**Planned Development
Minor Adjustment #1
Section 30, Township 35S, Range 40E
City of Fort Pierce, Florida**

Jenkins Road KOA
 Fort Pierce, Florida
 Planned Development Site Plan
 Minor Adjustment #1

Revision Summary:

Sheet **SP-1**

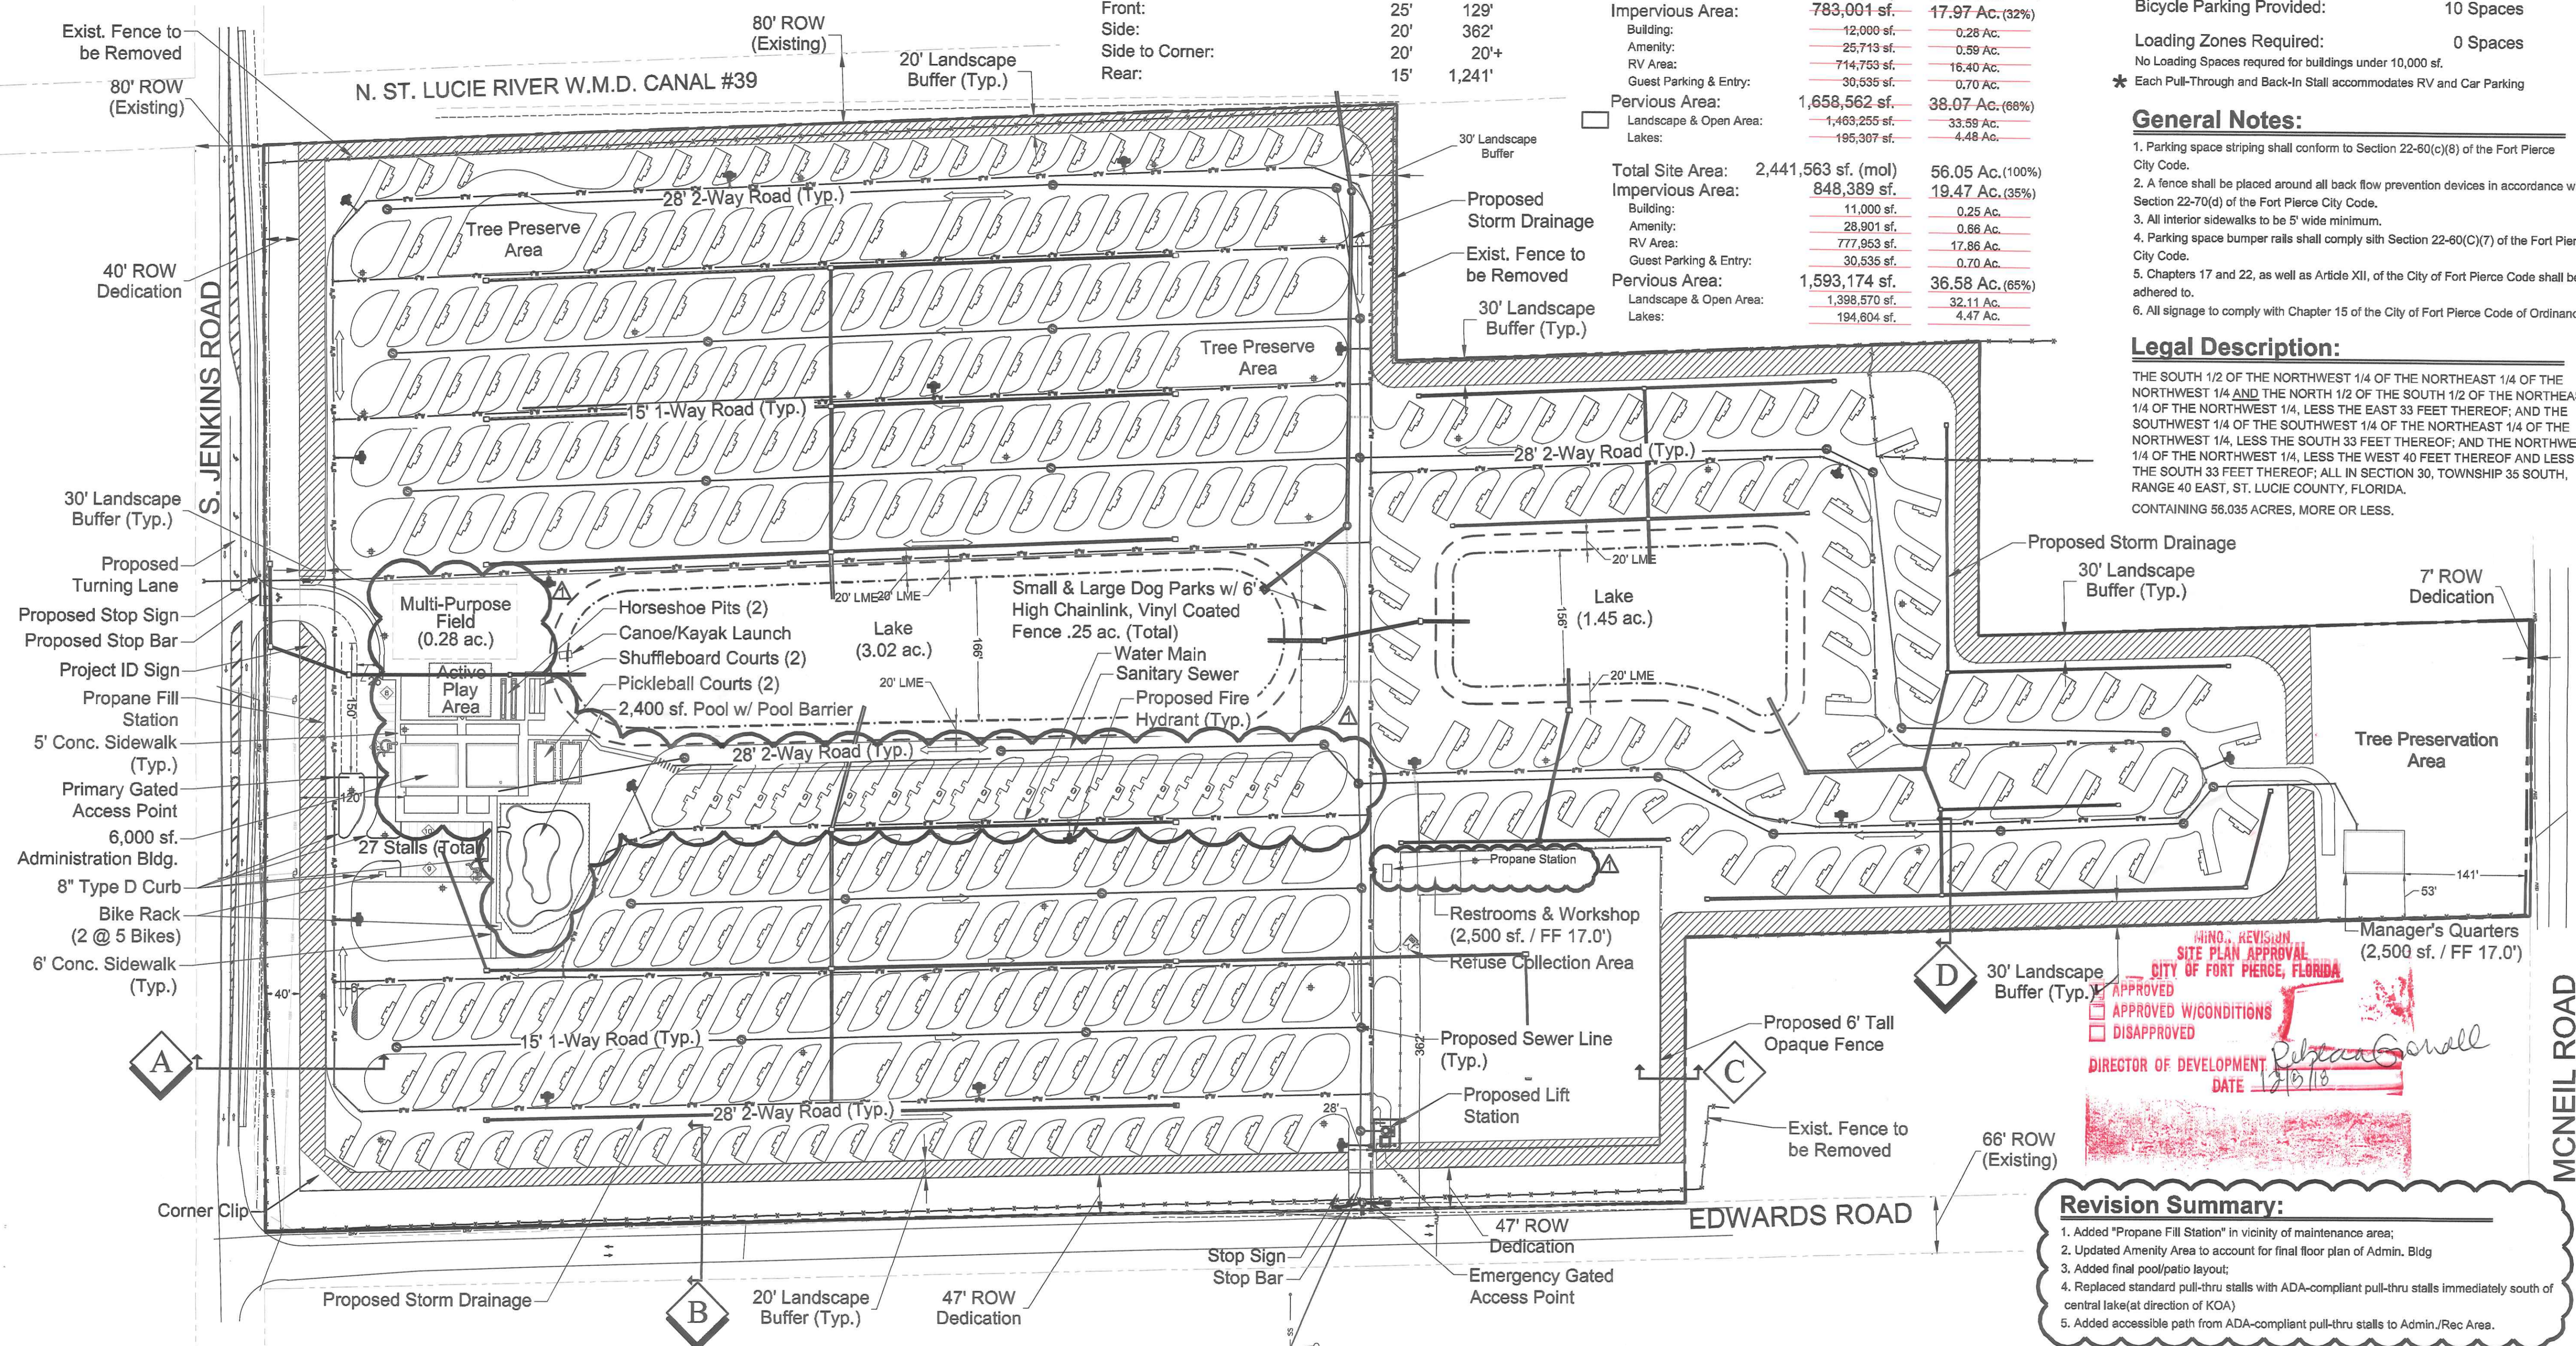
- Added "Propane Fill Station" in vicinity of maintenance area;
- Updated Amenity Area to account for final floor plan of Admin. Bldg
- Added final pool/patio layout;
- Replaced standard pull-thru stalls with ADA-compliant pull-thru stalls immediately south of central lake(at direction of KOA)
- Added accessible path from ADA-compliant pull-thru stalls to Admin/Rec Area.
